REMARKS

**AMENDMENTS TO THE DRAWING FIGURES**

Please enter the replacement sheet attached hereto containing Figs. 6-8. As shown in the attached annotated marked-up drawings, the replacement sheet contains a correction to one of the reference characters included in Fig. 7.

Fig. 7

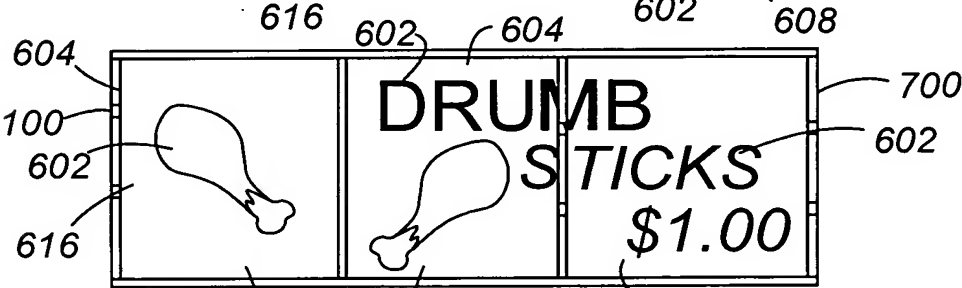
Fig. 7 has been amended as shown in the attached annotated marked-up drawing. Specifically, a typographical error has been corrected by changing one instance of reference numeral 604.7a to 604.7b. Support for this amendment can be found in the Specification, for example at page 10, lines 3-21. No new matter has been added by this amendment to Fig. 7. Accordingly, entry of the attached Replacement Sheet presenting amended Fig. 7 is respectfully requested.
